RS-16-121

Clinton Power Station, Unit 1  
Facility Operating License No. NPF-62  
NRC Docket Nos. 50-461 and 72-1046

Subject: Response to Request for Additional Information Concerning License Amendment  
Request to Incorporate Revised Alternative Source Term Dose Calculation in  
USAR

**ATTACHMENT**  
**Clinton Power Station, Unit 1**  
**Response to Request for Additional Information Related to License Amendment Request**  
**to Incorporate Revised Alternative Source Term Dose Calculation in USAR**  
**Page 1 of 6**

Environmental Zone Map  
Drawing Number M01-1600, - Sheet 6  
Auxiliary, Fuel & Containment Basement  
Floor Plan, EL 707'-6" & 712'-0"

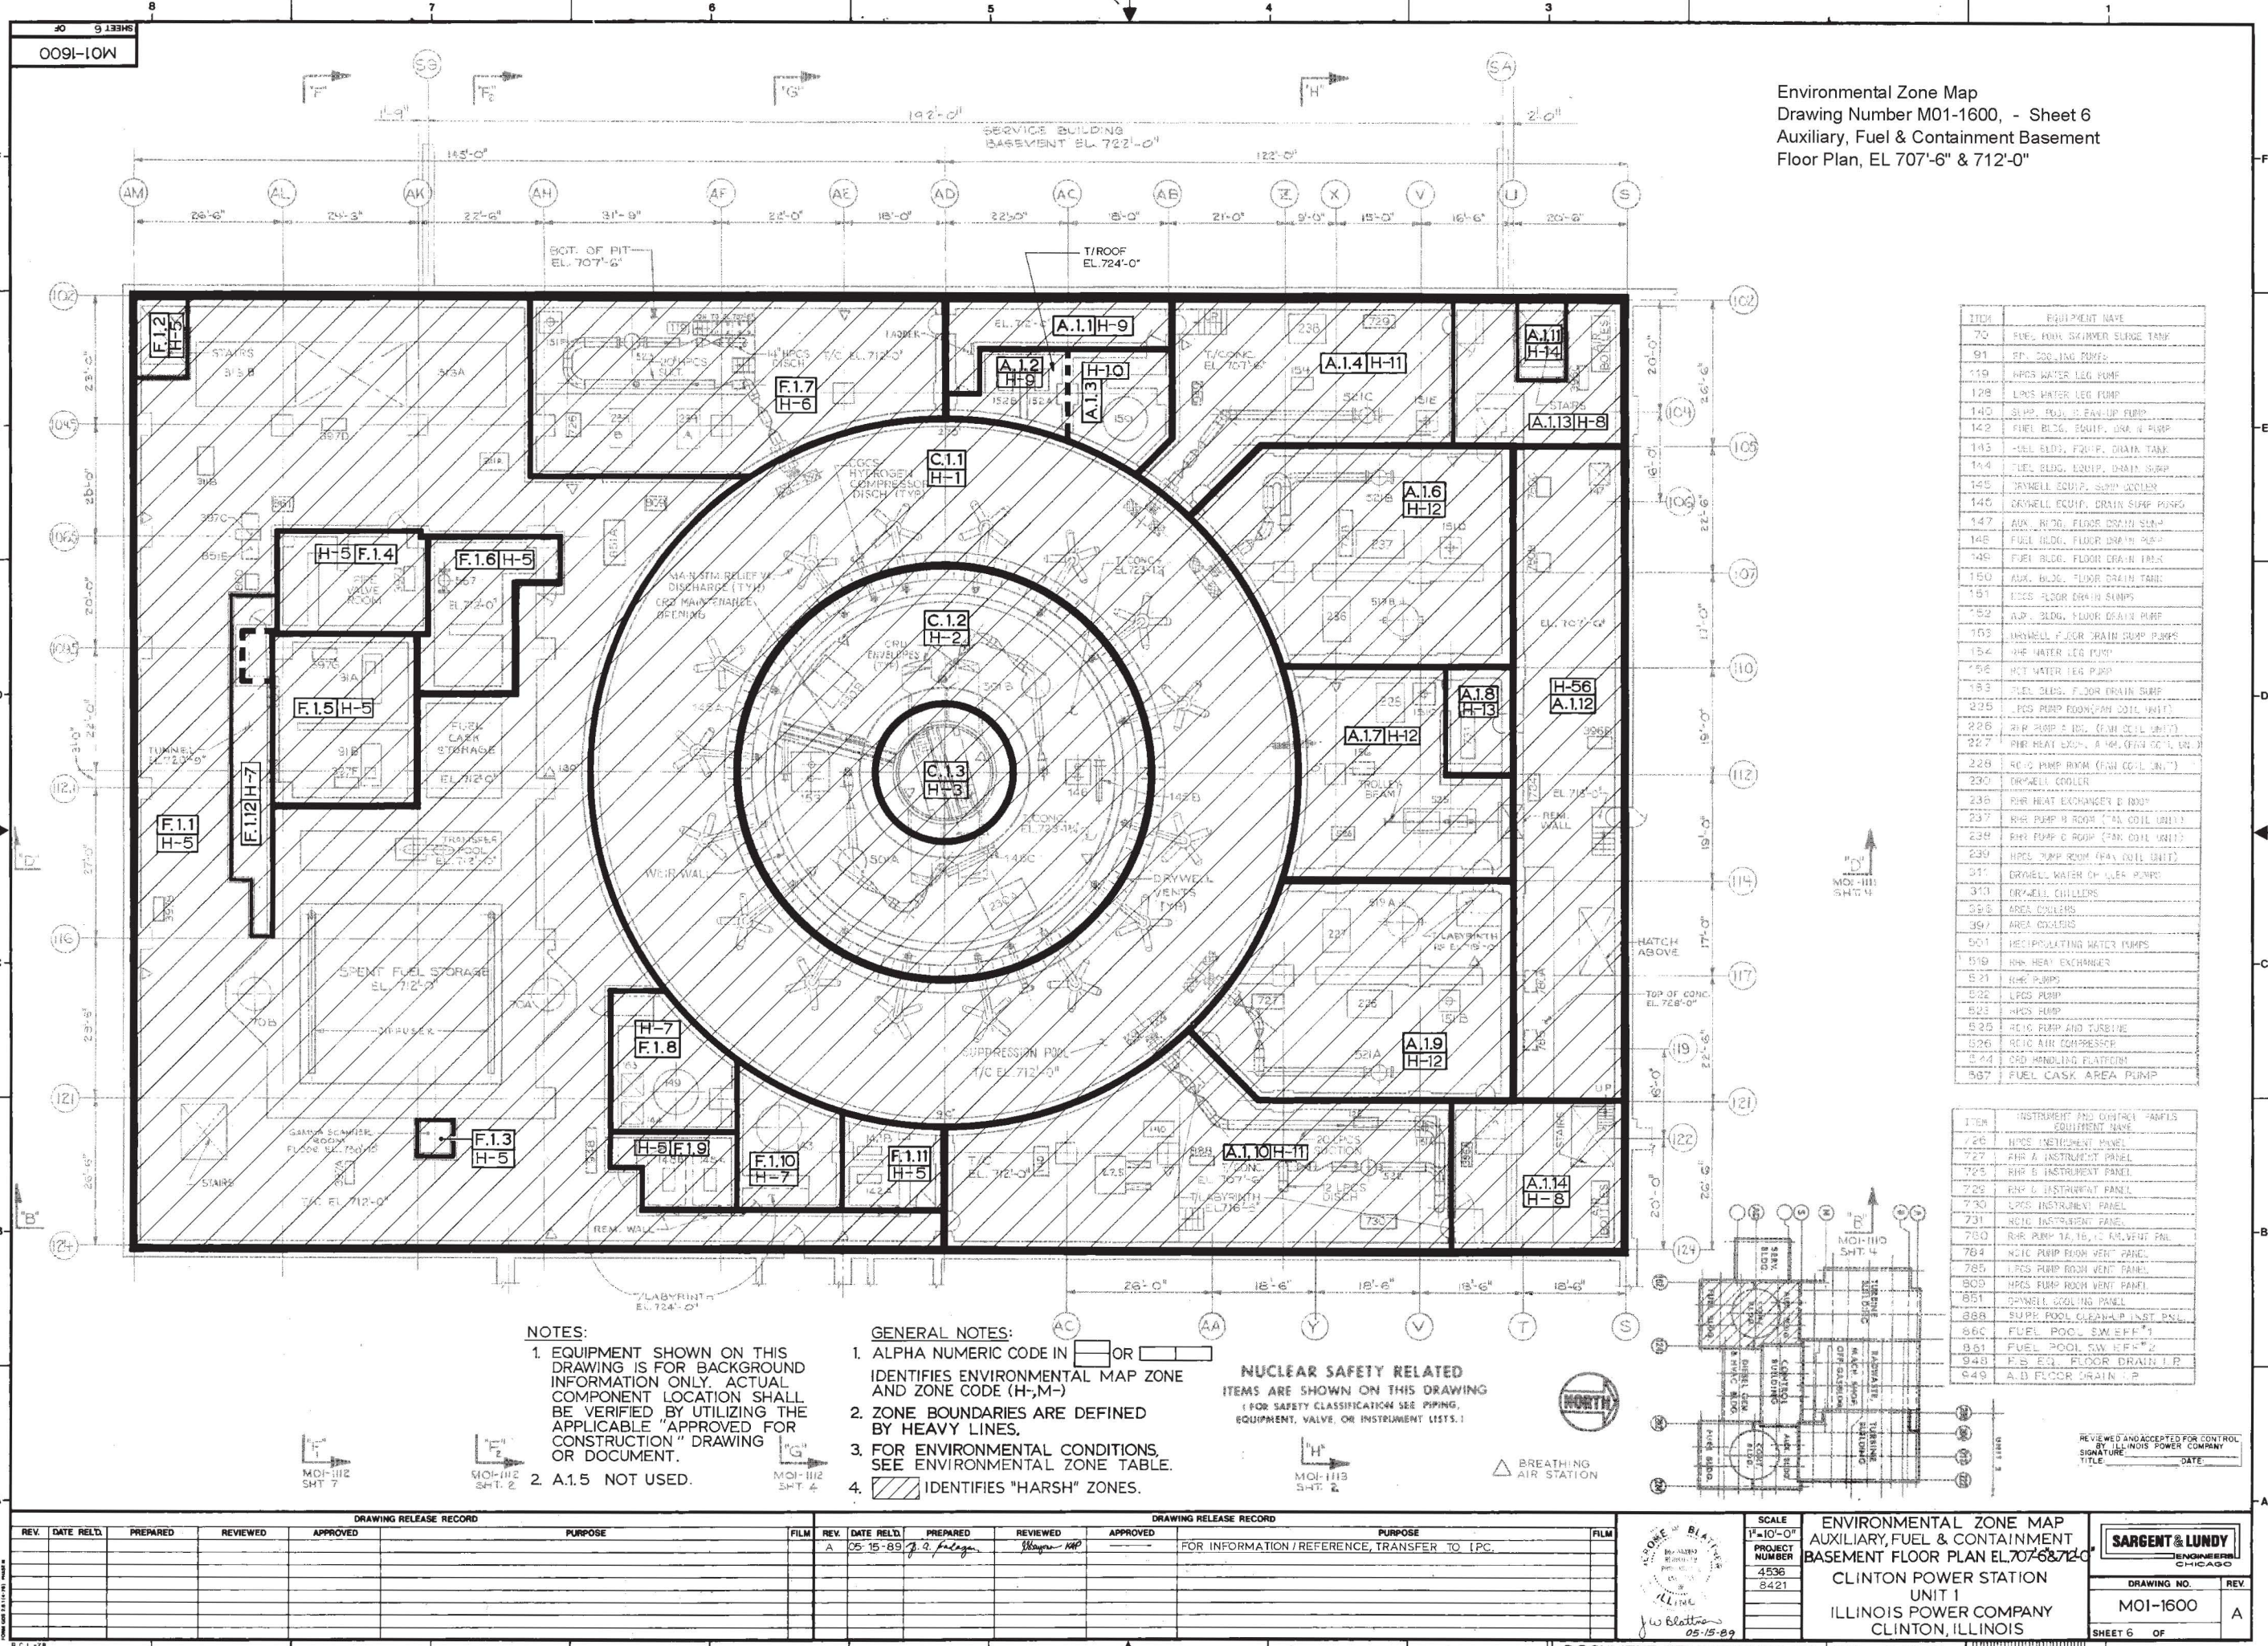
**RAI 3.d.**    *Provide revised environmental zone map(s) of the secondary containment that show all the affected environmental zones.*

The Enclosure to this letter provides the Environmental Zone Maps for those areas of the FB that would experience an analytical increase in the post-LOCA temperature, due to the presence of a fully loaded cask. This enclosure also includes a list of the affected Environmental Zones and the expected post-LOCA temperature increase. The Environmental Zone Maps only provide zone boundaries. There are no changes in zone boundaries.

The following provides the affected Environmental Zone Maps, and a list of zones and associated rooms that would experience an increase in the post-LOCA temperature due to the presence of a fully loaded spent fuel cask in the Fuel Building. This list also includes the current value for expected post-LOCA temperature (i.e., without a fuel cask) and the expected Post-LOCA temperature with the addition of a loaded cask.
